Re: ACTION RE: APPROVAL SITE PLAN AND DESIGN REVIEW FOR GREEN BAY AREA PUBLIC SCHOOL DISTRICT WEBSTER ELEMENTARY SCHOOL AT 2101 S WEBSTER AVENUE

Date: 21 February 2018

Site Plan & Design Review – Staff Comments

Site: 2101 S Webster Avenue (Parcel AL-58)
Development: Green Bay Area Public Schools (GBAPS) - Webster Elementary School
Developer Representatives: GBAPS – Michael Strangel – Executive Director of Facilities and Related Services
 Somerville – Duane Grove – Project Architect
 Robert E. Lee & Associates, Inc. – Patrick H. Kuehl, P.E. – Civil/Municipal Project Manager

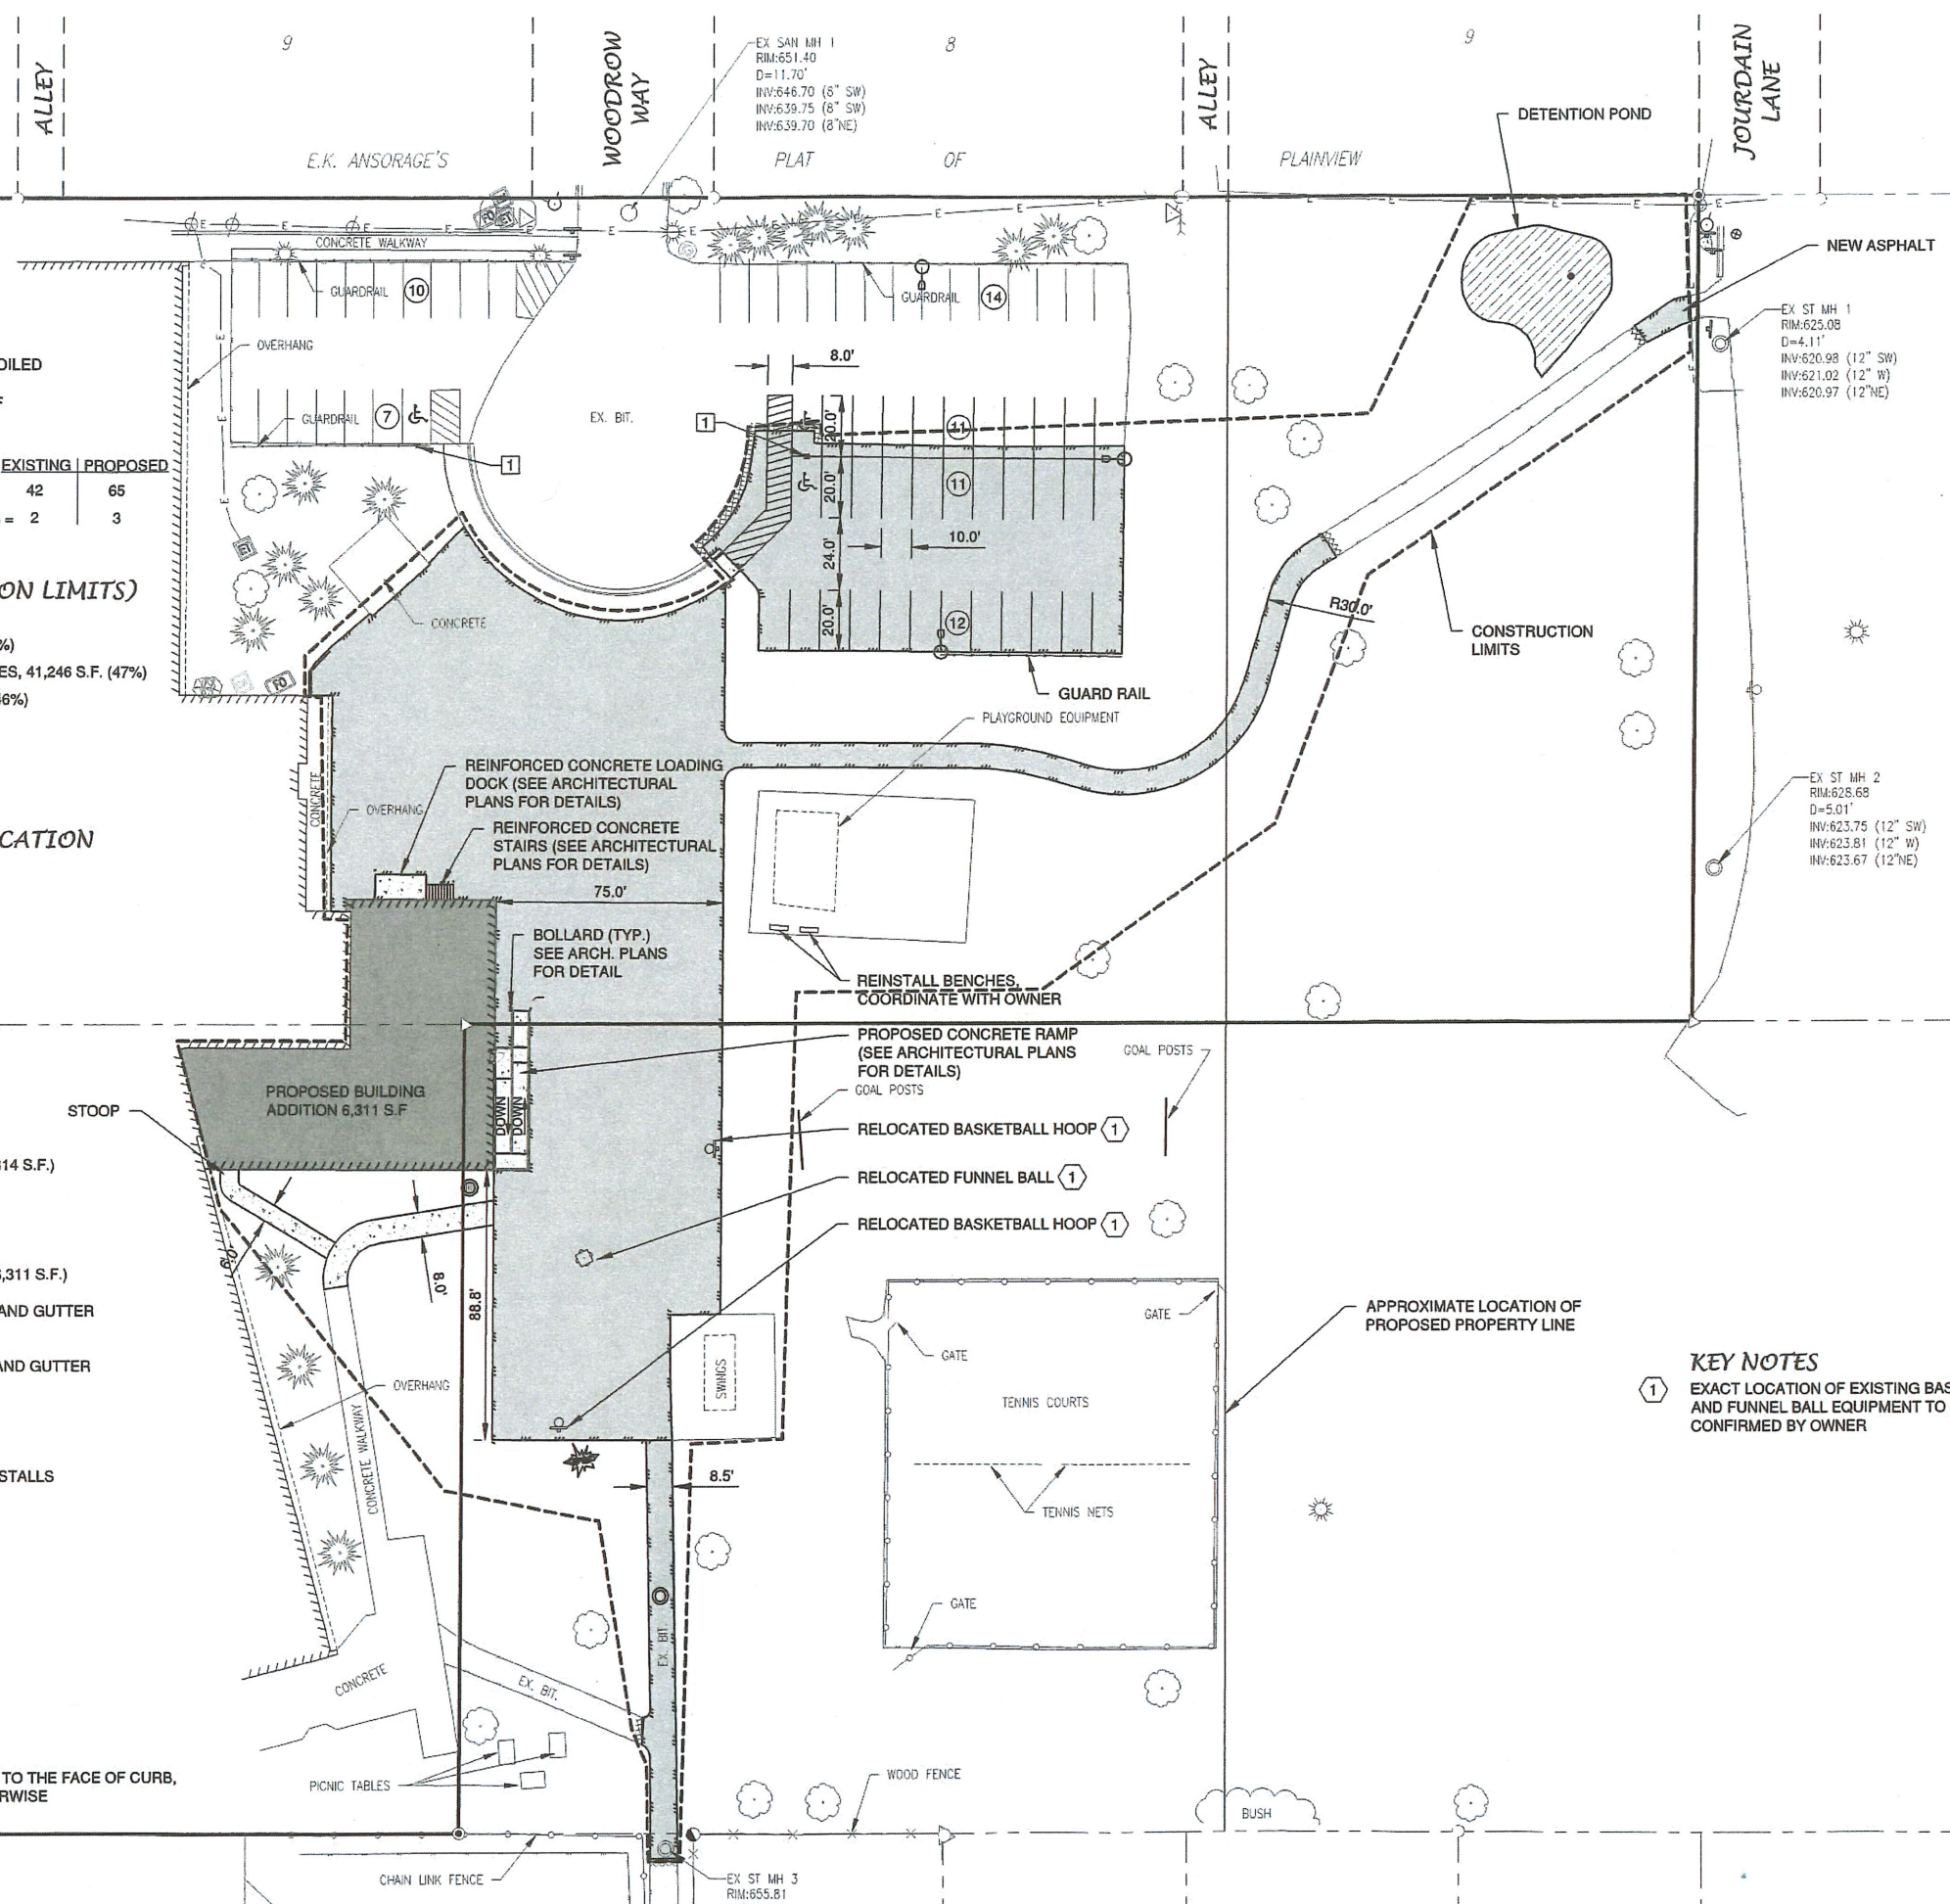
- Parks, Recreation, and Forestry Department review:
 - Approval should be contingent on land swap.
 - Woody vegetation northeast of the parking lot to deter sledding and screen parking lot from view.
 - Suggests the dry pond be planted with vegetation.

POTENTIAL LAND SWAP

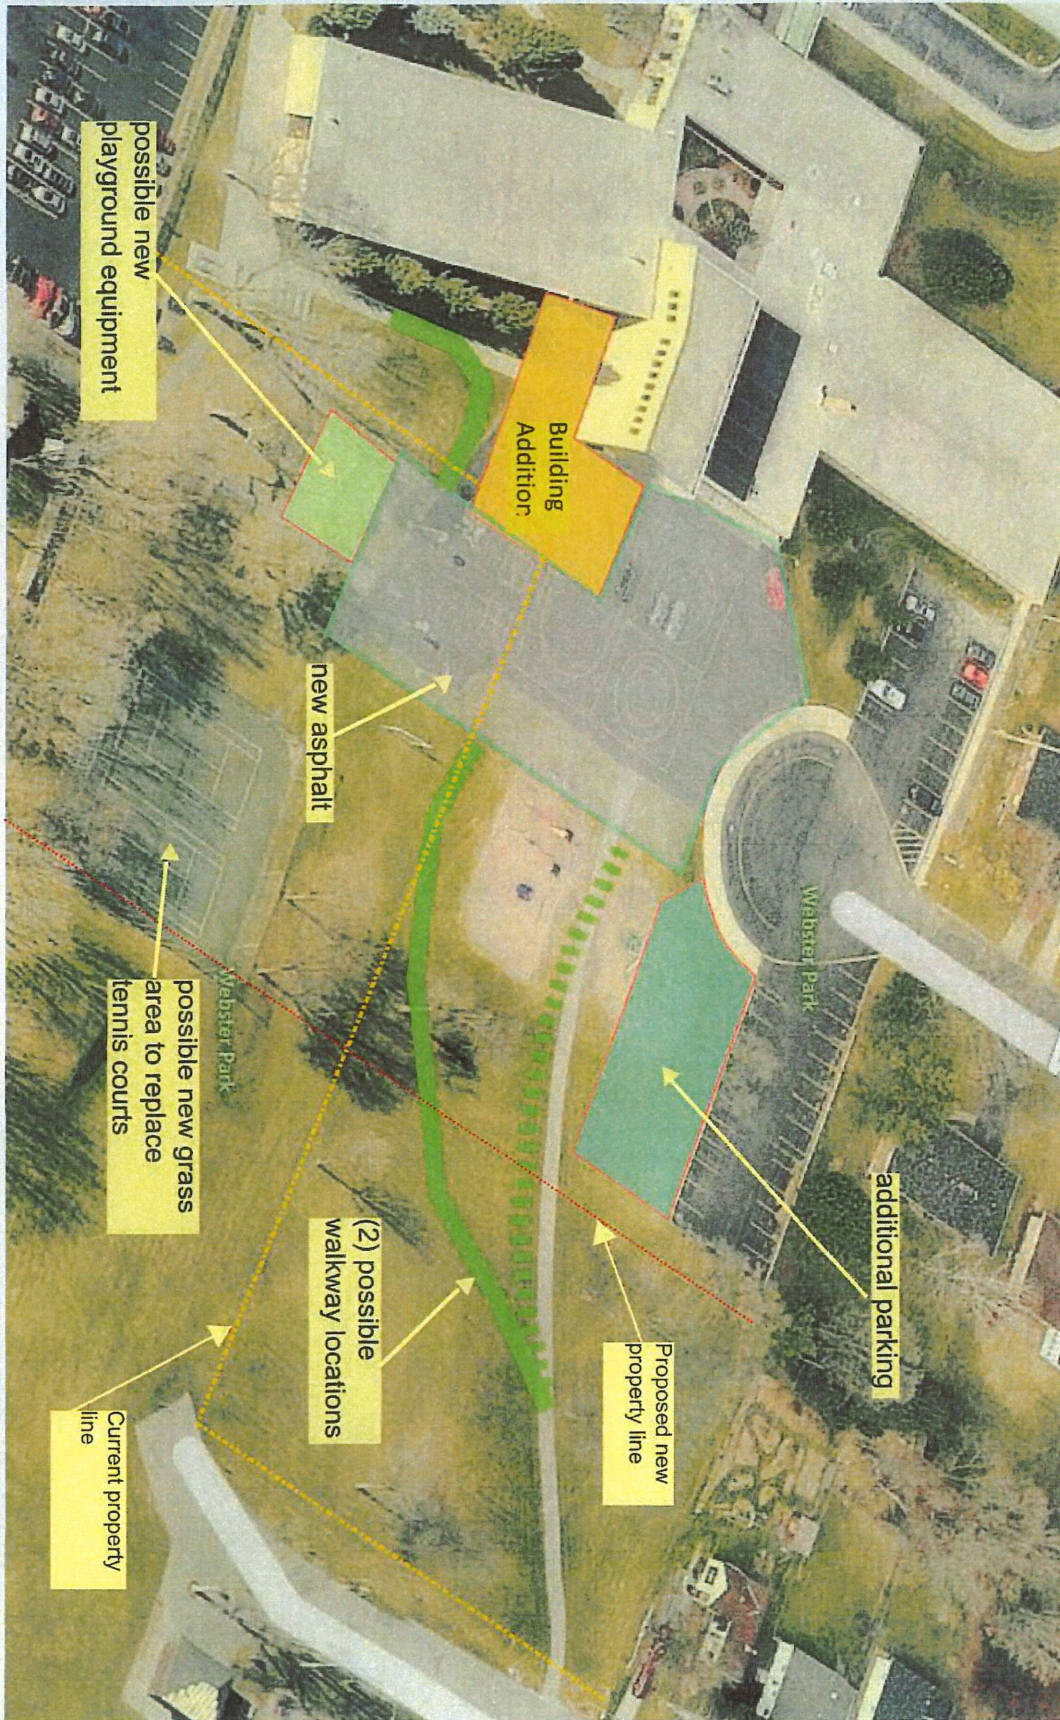
Zoning district		"A" Residential		
Building use (allowed)		Schools which are public or church-affiliated educational institutions		
		Required	Provided	Notes
Height		Lesser of 35' or 2½ stories	26'	
Lot	Area	7,500SF minimum	87,457SF (2 acres)	Site area should be adjusted with or without land swap.
	Frontage	100' minimum	540'	Measurement based on Brown County aerials.
	Green space	N/A for public and semipublic buildings, such as churches, schools and hospitals	N/A	
Setback	Front	30'	Existing	
	Side (inner)	10'	Existing	
	Side (corner)	N/A	N/A	
	Rear	30'	235'(with land swap); On park property (without land swap)	Calculation based on Brown County aerials. Should be noted on plans. Approval needs to be contingent on land swap.
Parking	Number	Elementary, middle or junior high school (1 stall / 5 seats provided in the main assembly rooms)	65	
	Size	10'x20'	Standards met	
	Bicycle	Bicycle parking should be provided	Standards met
